February 5, 2013

**Subject: Model Water Quality Management Plan and Technical Guidance Document Errata;  
Order No. R8-2009-0030**

# TECHNICAL GUIDANCE DOCUMENT ERRATA SHEET #2

## FEBRUARY 5, 2013

FIGURE  
XVI-3d

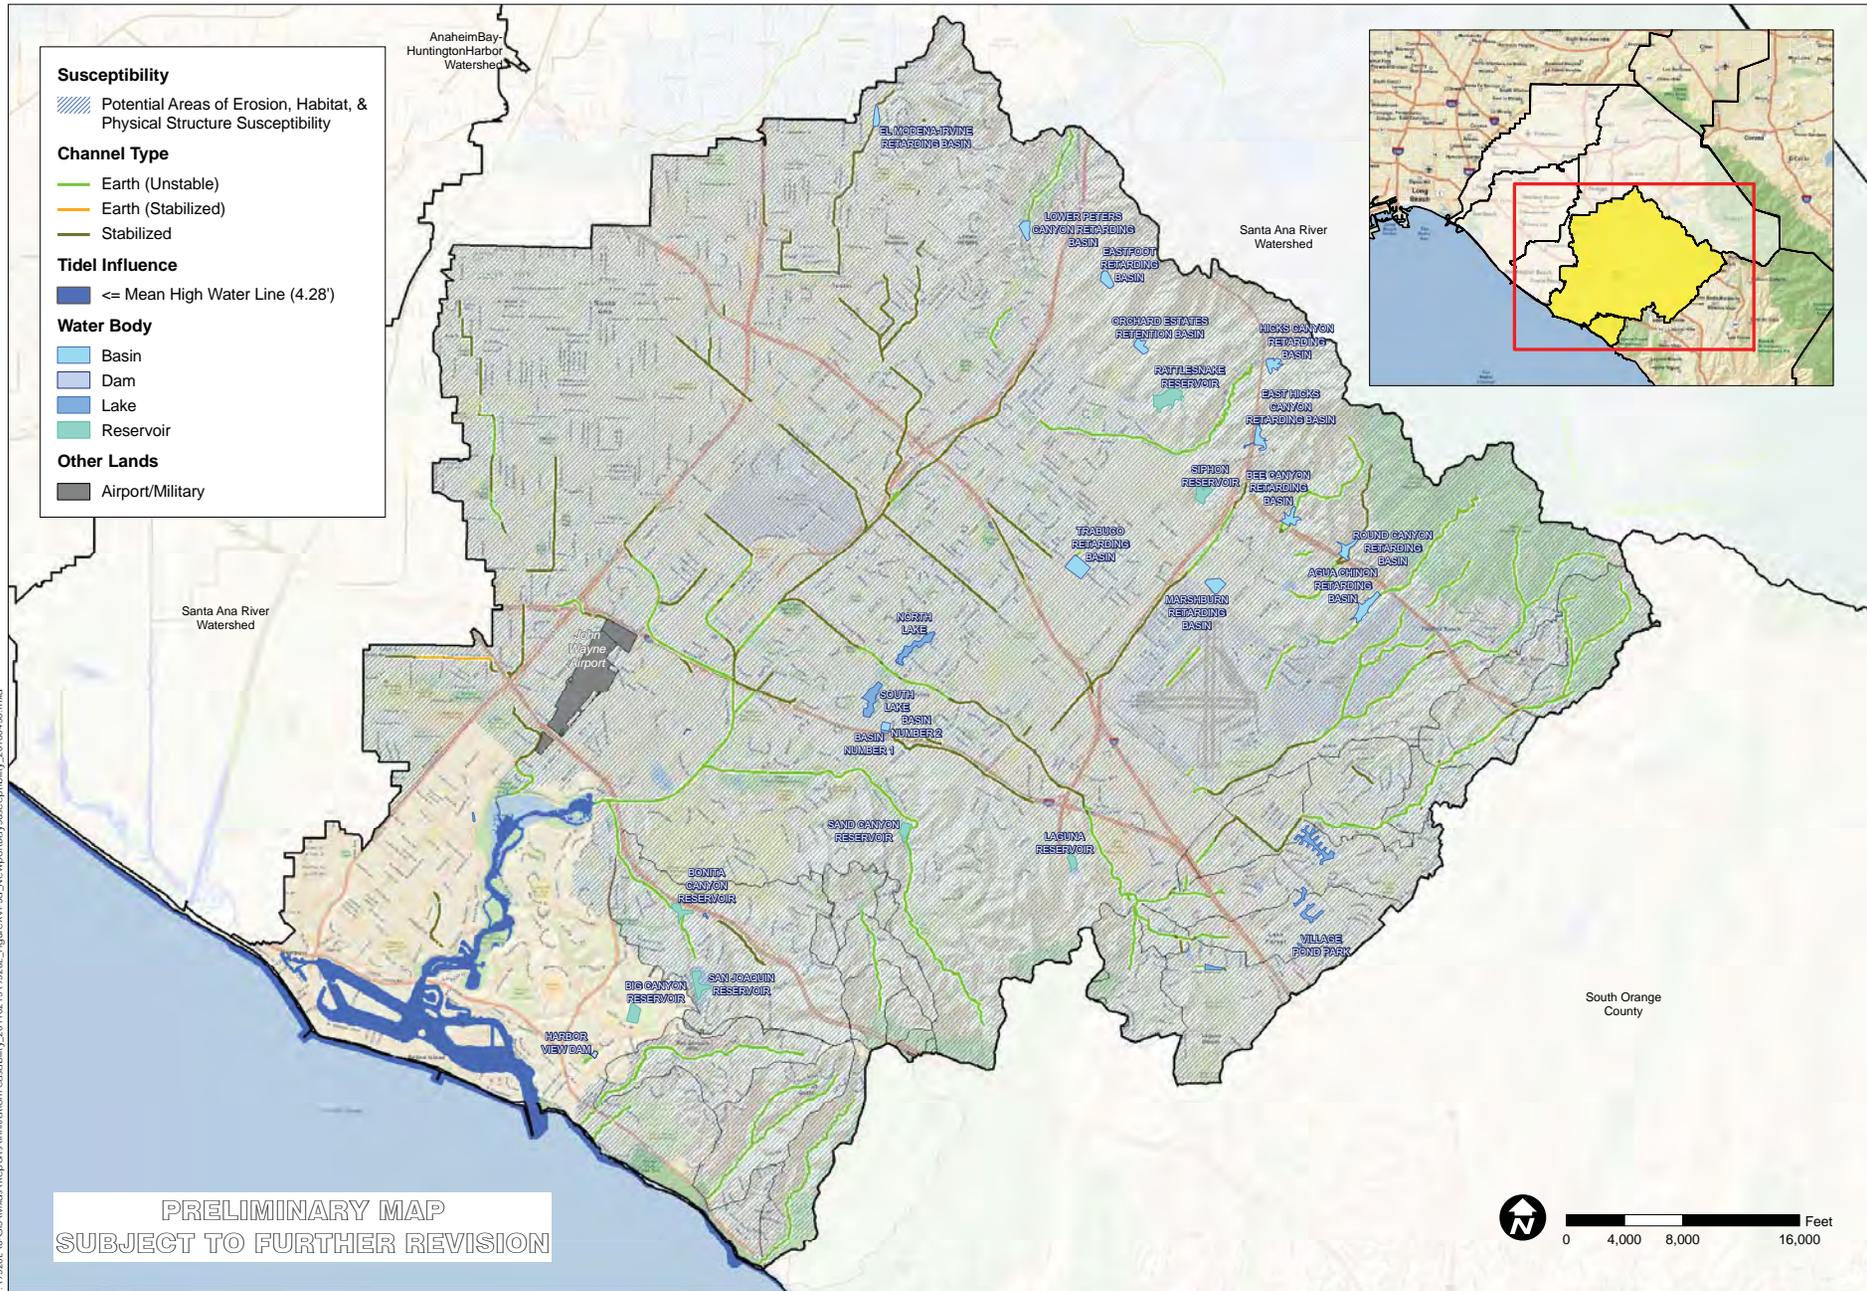
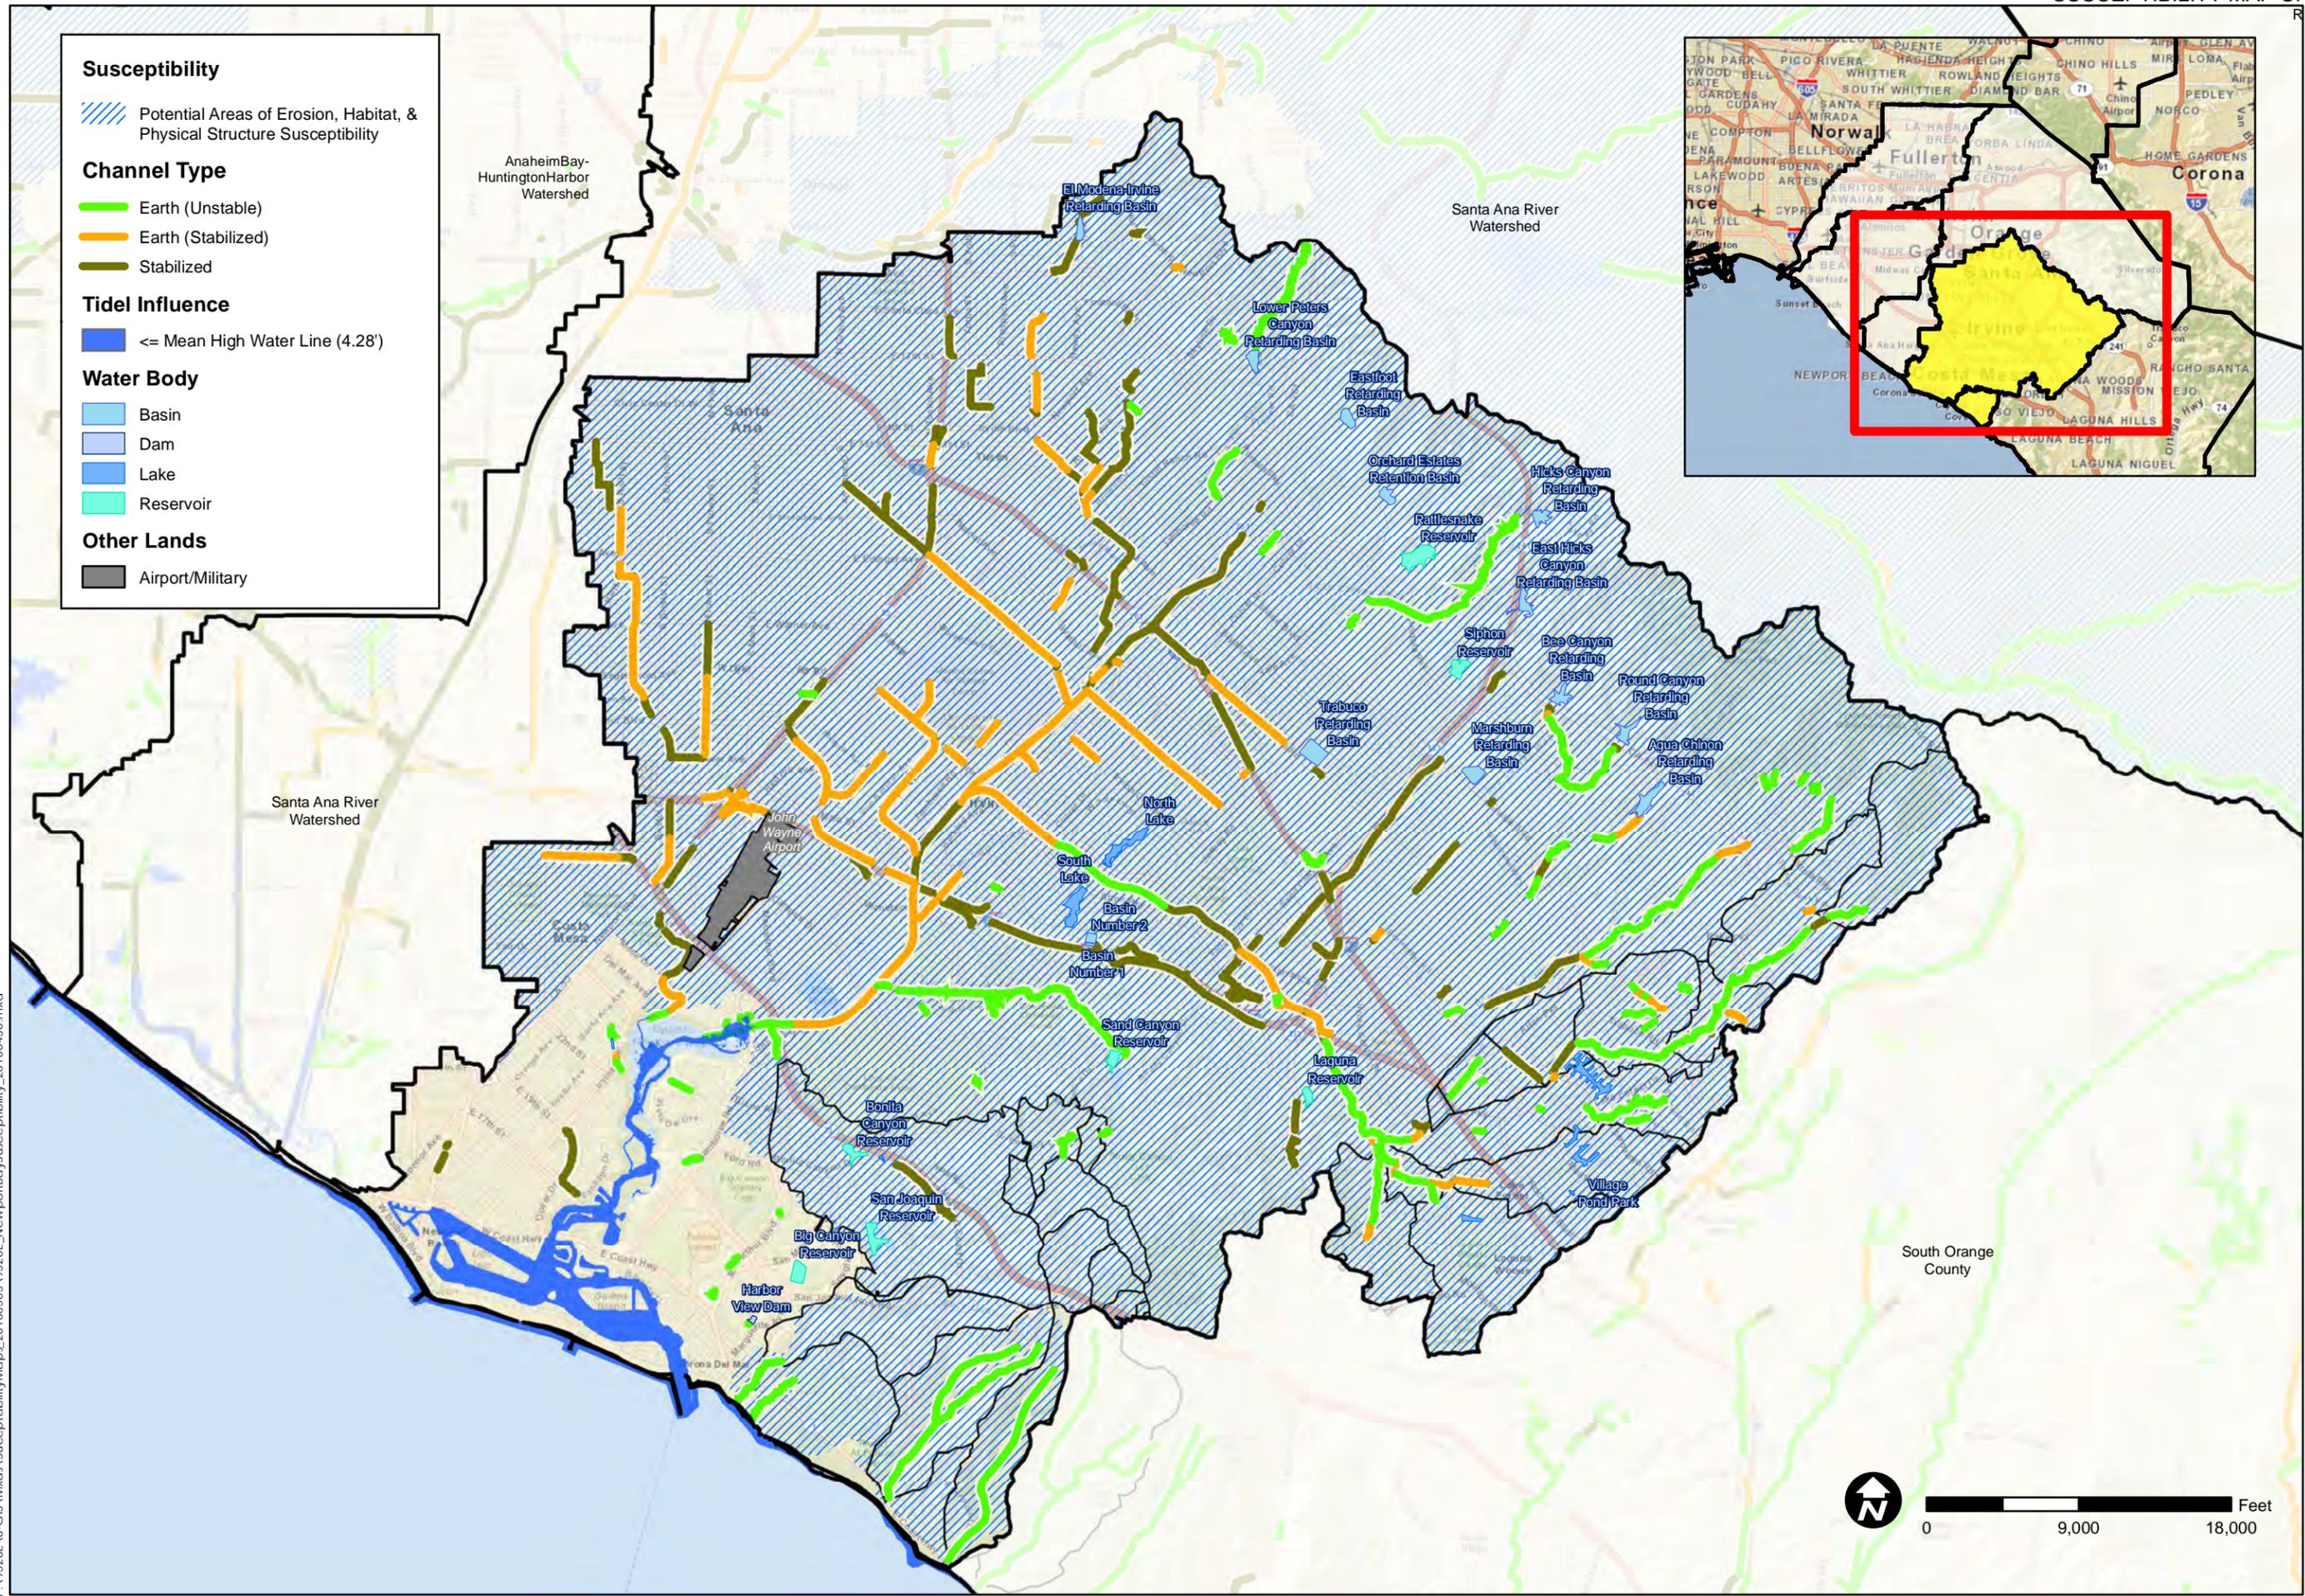
- A total of 14,416 linear feet of channel changed from Earth (Unstable) to Earth (Stabilized)
- Channels:
  - BORREGO CANYON CHANNEL = 242 ft.
  - SANTA ANA-SANTA FE CHANNEL = 971 ft.

- PETERS CANYON CHANNEL = 845 ft.
  - CENTRAL IRVINE CHANNEL = 445 ft.
  - SAN DIEGO CREEK CHANNEL = 2,275 ft.
  - PAULARINO CHANNEL = 361 ft.
  - LA COLINA-REDHILL STORM DRAIN = 137 ft.

- EL MODENA-IRVINE CHANNEL = 650 ft.
  - REDHILL CHANNEL = 50 ft.
  - COMO STORM CHANNEL = 812 ft.
  - LANE CHANNEL = 870 ft.
  - CANADA CHANNEL = 274 ft.

- ARMSTRONG STORM CHANNEL = 325 ft.
  - BARRANCA CHANNEL = 975 ft.
  - BEE CANYON CHANNEL = 975 ft.
  - SAN JOAQUIN CHANNEL = 260 ft.
  - AGUA CHINON CHANNEL = 49 ft.

- VEEH STORM CHANNEL = 20 ft.
  - AIRPORT STORM CHANNEL = 154 ft.
  - SANTA ANA-DELHI CHANNEL = 739 ft.
  - SANTA ANA GARDEN CHANNEL = 864 ft.
  - VALENCIA STORM CHANNEL = 149 ft.

- Unnamed Channels = 1,974 ft.
